Village of Oak Harbor, Ohio
WWTP Improvements
Rebid

ADDENDUM 3

October 30, 2026

OAK HARBOR, OHIO
WASTEWATER TREATMENT PLANT
PRE-BID QUESTIONS

SHEET NO.
A-2.9
57 OF 247

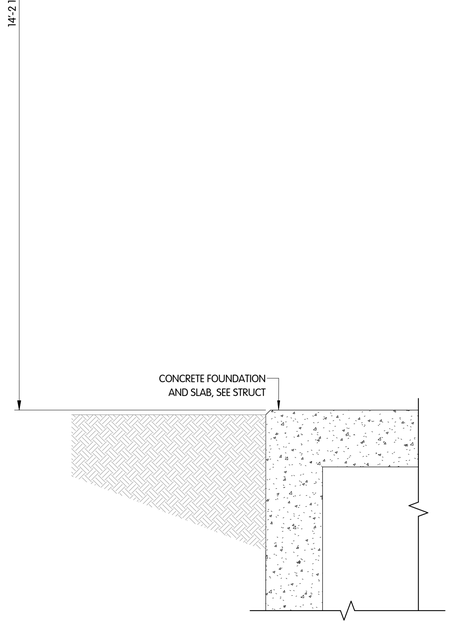
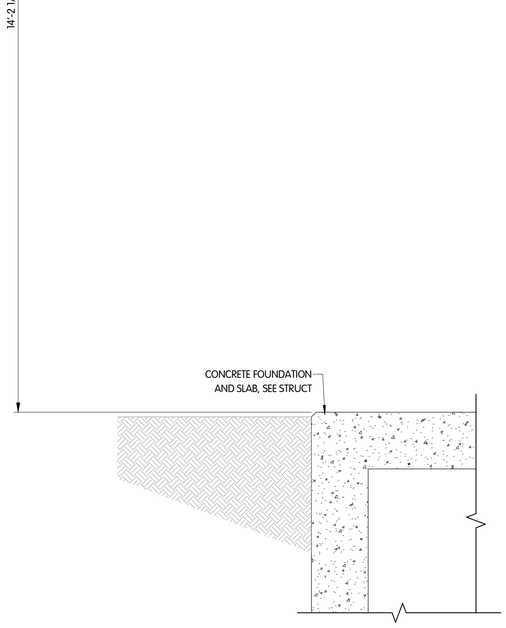
24. *At the Headworks Building can you please confirm if the canopy area is to have just a plywood soffit or an aluminum soffit? Detail 6/A-2.8 just calls for "Plywood Soffit", while details 7 & 8 / A-2.9 call for "Soffit with Alum. Soffit System (Typ).". If this area is to have an aluminum soffit, is the soffit to attach directly to the bottom of the roof trusses or should this area have plywood sheathing that the soffit attaches too?*

SHEET NO.
S-10.2
119 OF 247

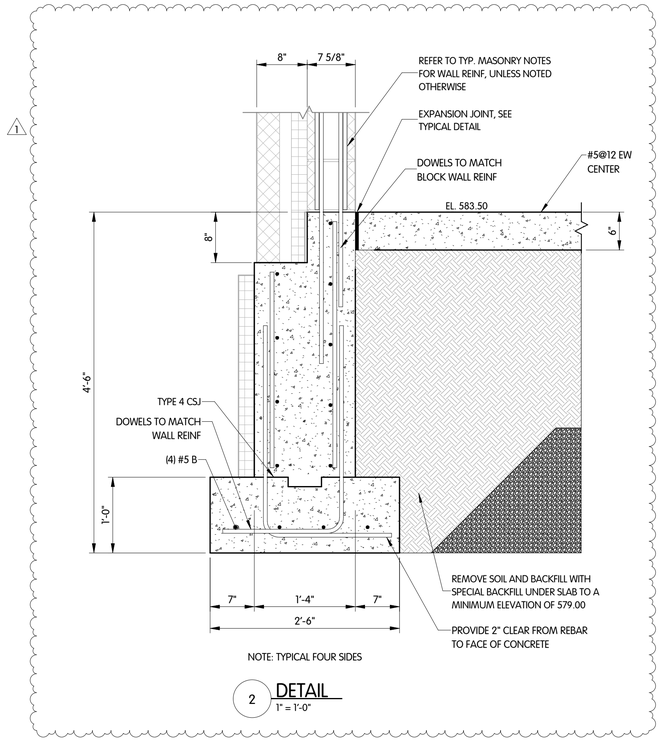
8. *Electrical Building: Detail 2 on drawing S-10.2 shows a typical detail for the footer and foundation wall make-up of the foundation walls on the Electrical Building. However, top of footer and bottom of footer elevations are NOT provided.*

a) *Can you please provide a top of footer and bottom of footer elevation for the footers of the Electrical Building? Can you please update Detail 2 on drawing S-10.2 via Addendum with the requested information?*

9. ***Electrical Building:*** *Can you please advise on desired slab thickness for the floor slab in the Electrical Building? Detail 2 on drawing S-10.2 appears to scale to a 5" thick slab.*

See Addendum 3, Revised Sheet S-10.2

See Addendum 3, Revised Sheet S-10.2

STATUS: ISSUED FOR RE-BID
DATE: AUGUST 2026
SHEET NO.
S-14.1
121 OF 247

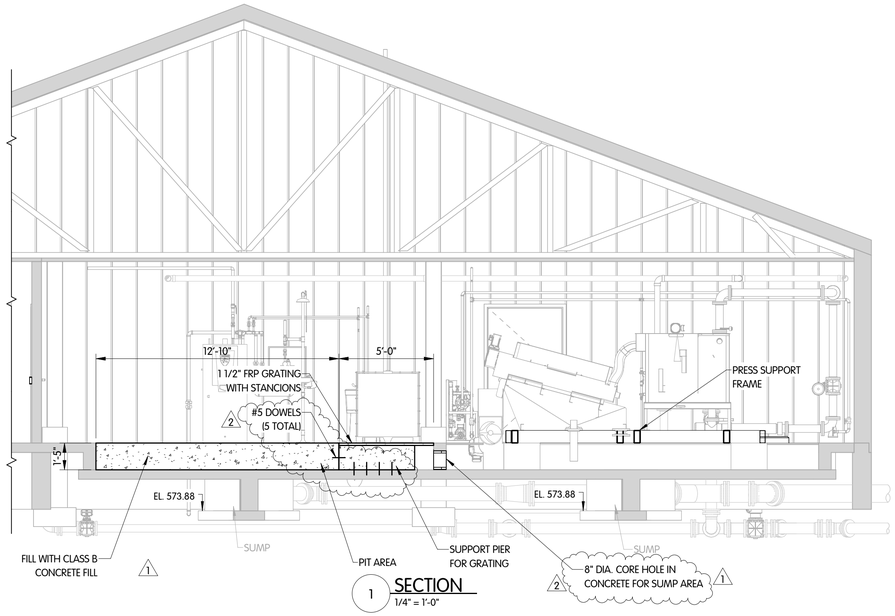
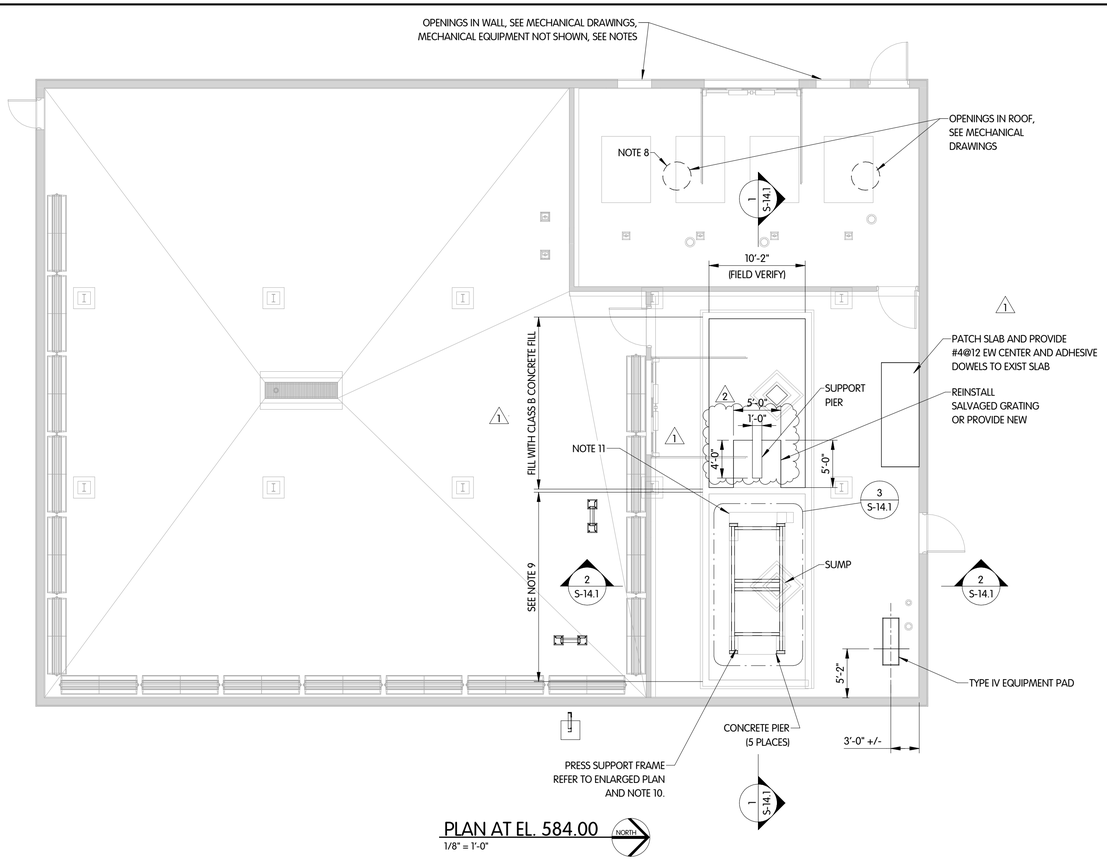
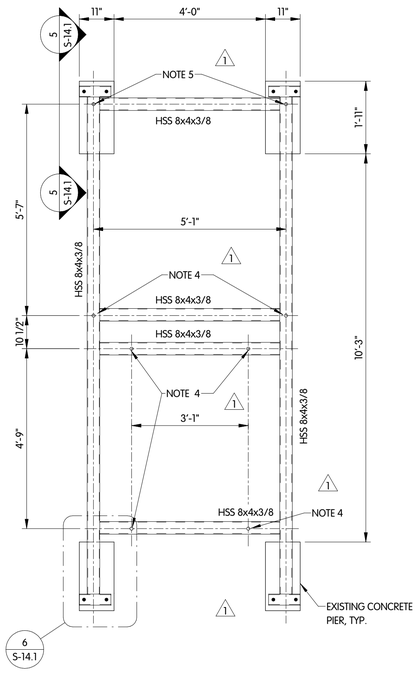
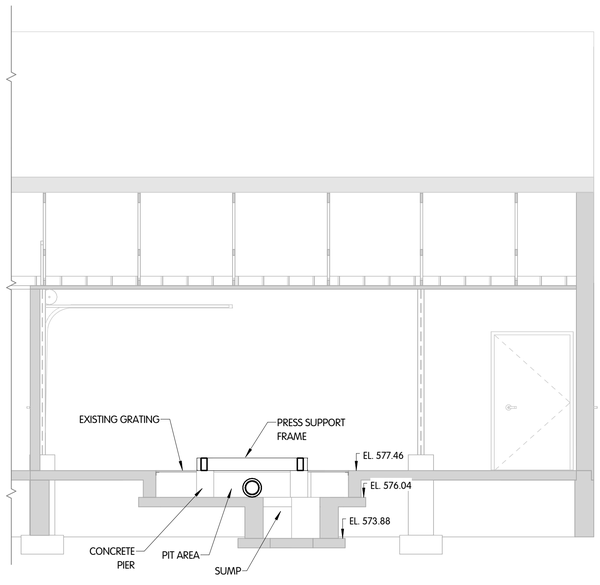
12. ***Blower Buildi****ng: Per drawing S-14.1 the Contractor is to pour a 1'-5" thick cast-in-place slab in the West Chamber of the Blower Building. No reinforcing steel is shown for the 1'-5" thick slab.*

a) *Can you please provide desired reinforcing steel for the 1'-5" thick slab?*

13. ***Blower Building:*** *Drawing S-14.1 depicts a sump (El. 573.88) below the new 1'-5" thick cast-in-place slab in the West Chamber of the Blower Building. Can you please advise if the sump is to be abandoned and infilled with concrete? If not, is the intent to utilize the existing sump as a containment sump for the new Polymer Totes?*

14. ***Blower Building:*** *Drawing S-14.1 shows a singular "support pier" shown on the Eastern most side of the West Chamber of the Blower Building. No dimensional information, nor any reinforcing requirements are shown for this pier.*

a) *Can you please provide dimensional information for the proposed "support pier"?*

b) *Can you please provide the desired reinforcing steel for the support pier?*

15. ***Blower Building:*** *Drawing S-14.1 indicates that the East Chamber of the Blower Building is to have (4) new 11" x 1'-11" x 1'-5" Tall Support Piers cast into the Chamber to support the new S.S. Press Support Frame. No information is provided on the desired reinforcing steel for the (4) new Support Piers.*

a) *Can you please provide the desired reinforcing steel for the support piers?*

Per Drawing S-14.1, the new sump in the west well, which will be partially filled with concrete, is connected to the east well, sludge press location, by a new 8-inch opening between the two. No spill containment pallet is required.

See Addendum 3, Revised Sheet 14.1

STATUS: ISSUED FOR RE-BID
DATE: AUGUST 2026
SHEET NO.
PE-2.4
131 OF 247

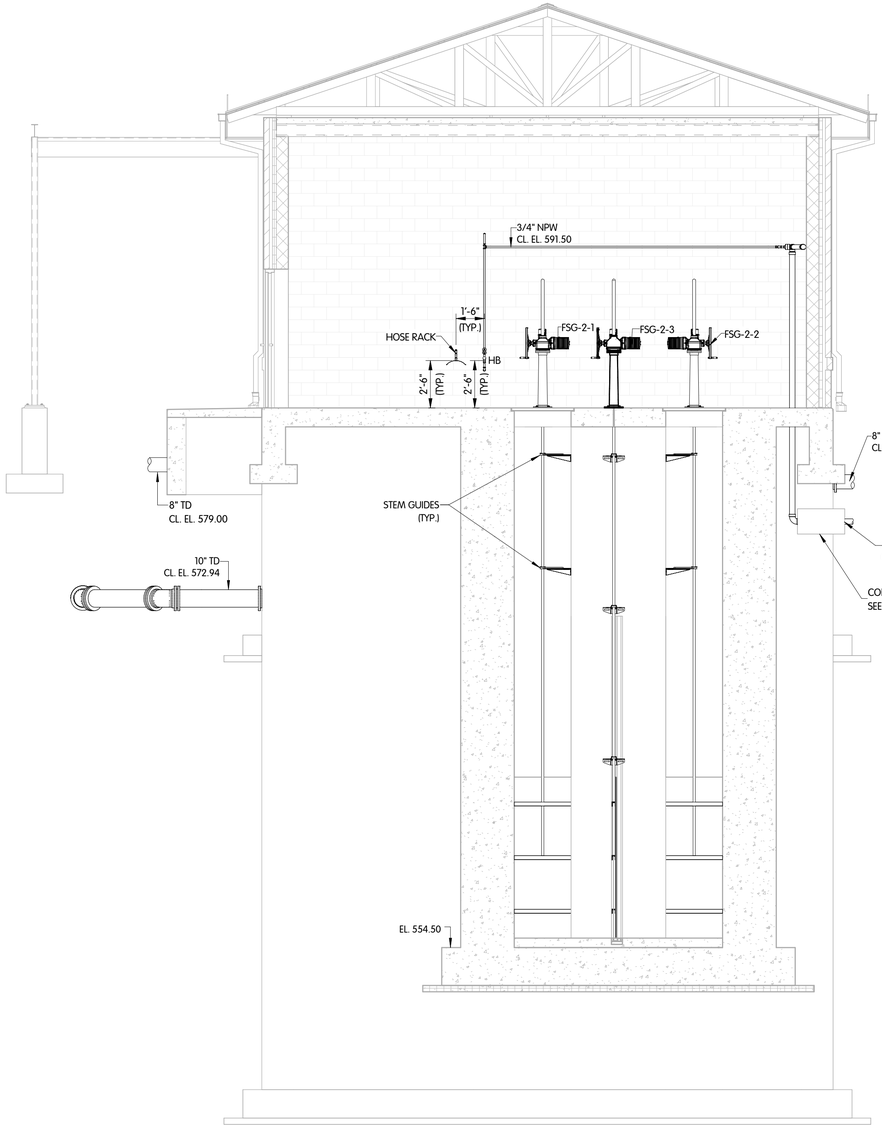
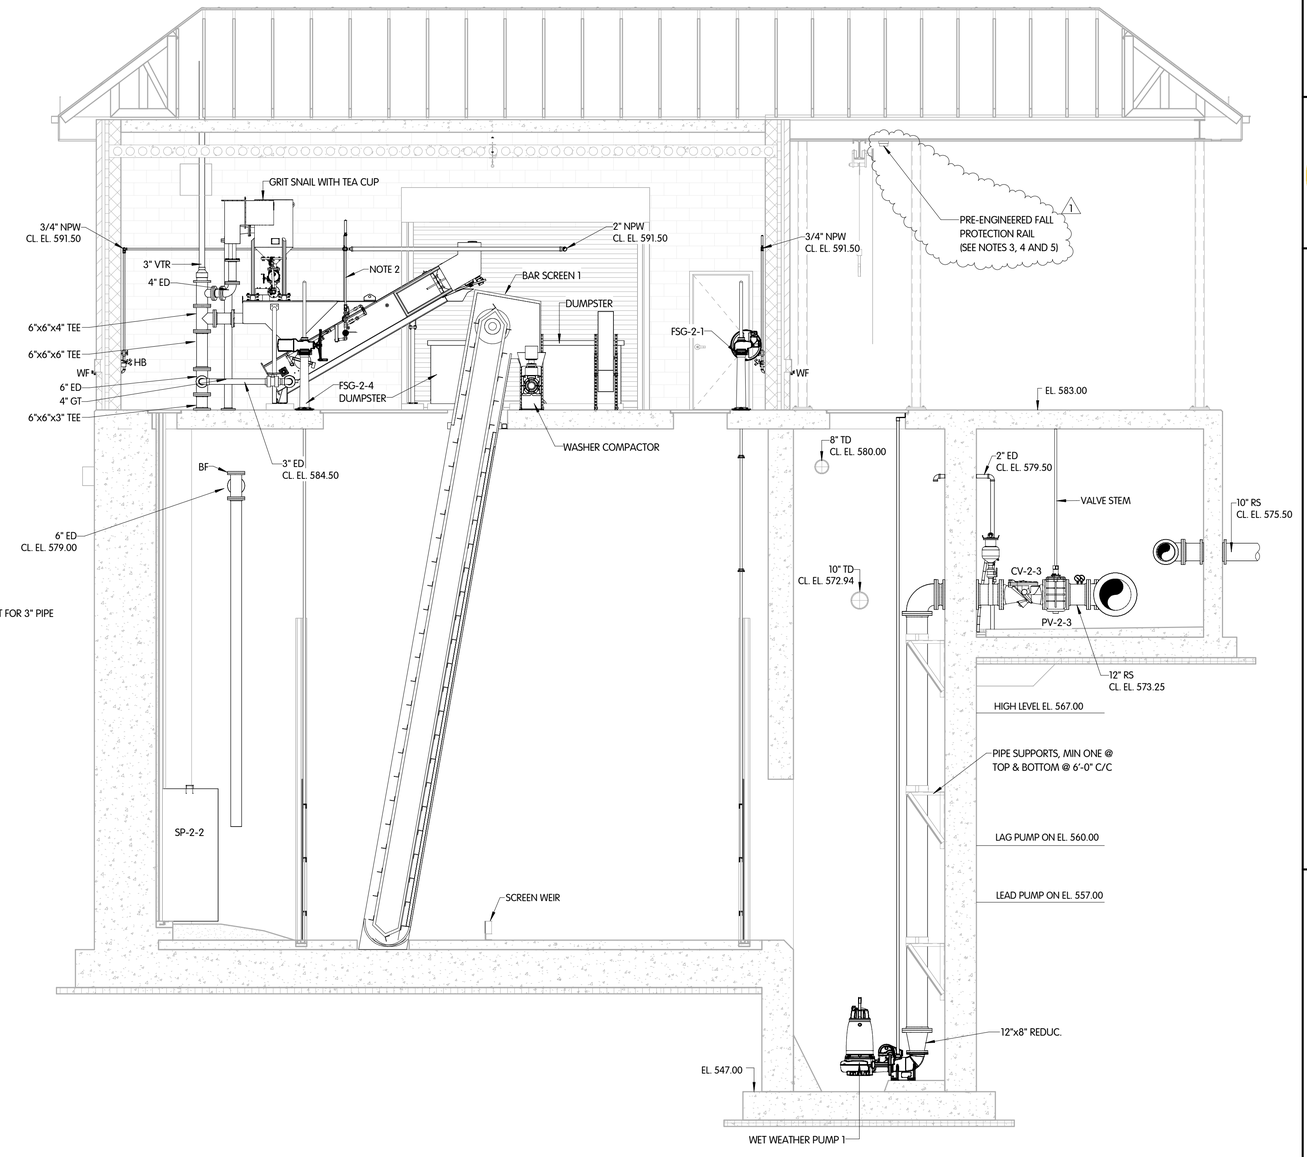
4. *In reference to plan sheets A2.2 and S4.1, a "Pre-Engineered Fall Protection Rail System" is called out. Please provide specifications for this rail system.*

See Addendum 3, Revised Sheets PE-2.4- and PE- 3.0

SHEET NO.
E-101.1
190 OF 247

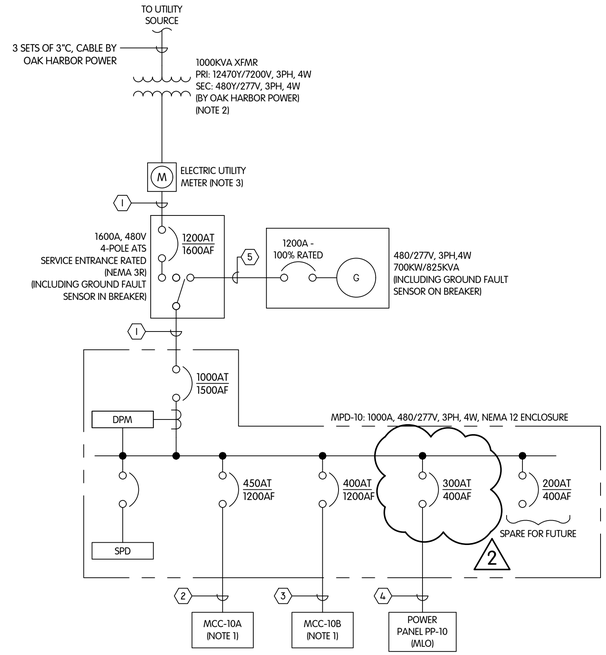
7. *In reference to plan sheet E101.1, the Plant Single Line Drawing calls out the conduit between the incoming Utility and the transformer to 3 sets of 3" conduit, based on the Electric Site plan and the duct bank cut sections on E-100.2 and E-0.4 it calls it out as section Q with over 20 conduits ran between them. Please confirm which is correct.*

36. *On the Plant Single Line Drawing on drawing E101.1 it calls out the conduit between the incoming Utility and the transformer to 3 sets of 3" conduit, based on the Electric Site plan and the duct bank cut sections on E-100.2 and E-0.4 it calls it out as section Q with over 20 conduits ran between them. Please confirm which is correct.*

See Addendum 3, Revised Drawings E-101.1 and E-0.4.
